City of Seattle

STANDARD SYMBOLS
SEWER & DRAINAGE

PARALLEL CURB RAMPS (CORNER)
(TYPE 422C)

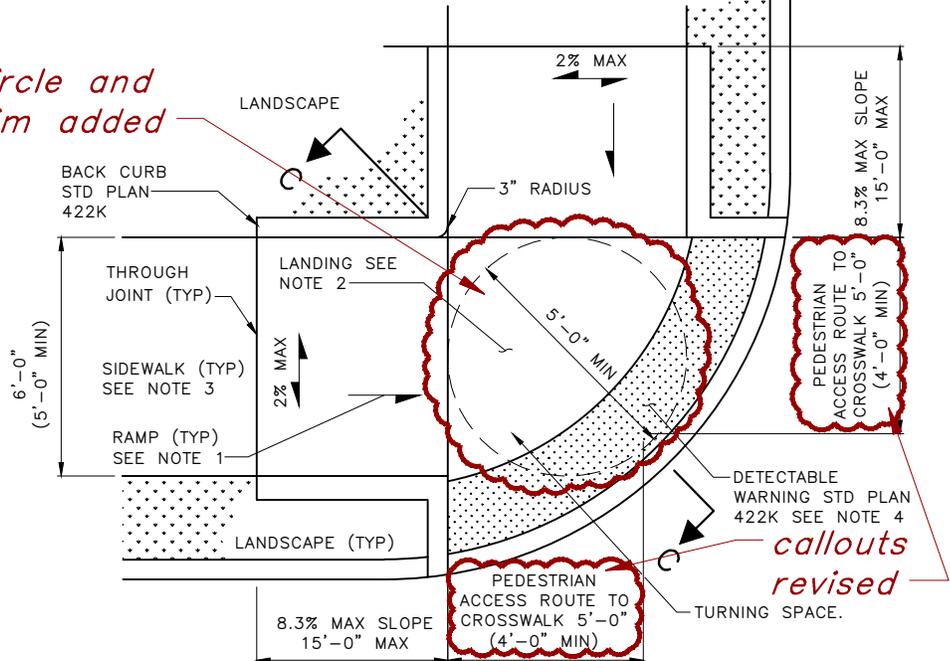
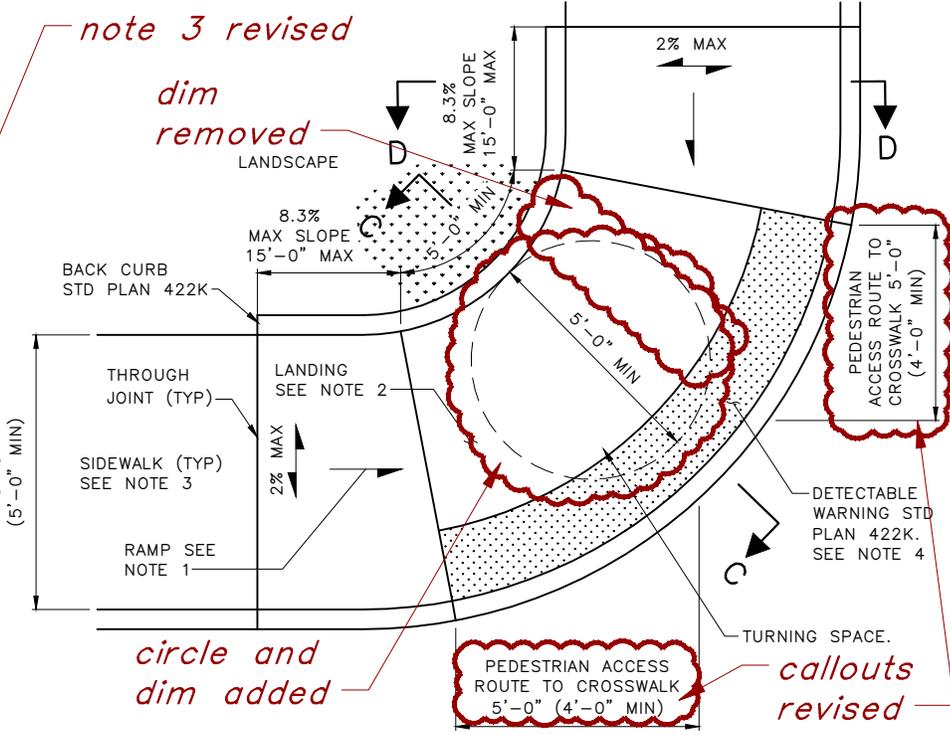
circle and dim added

circle and dim added

callouts revised

callouts revised

circle and dim added

callouts revised

770C
BIKE SYMBOL

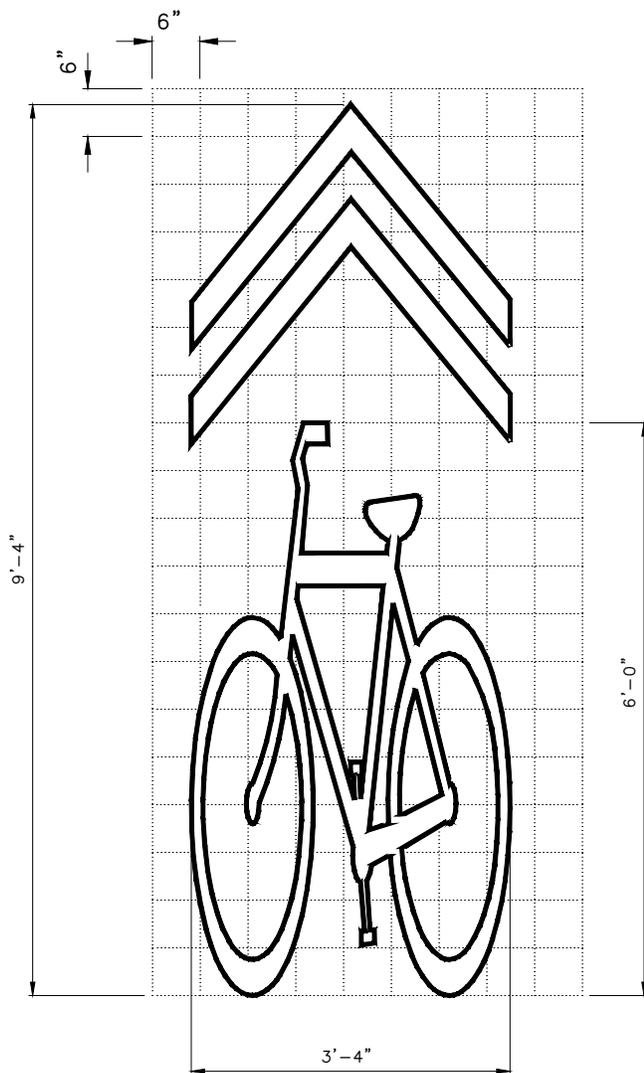
bike revised

tilte revised
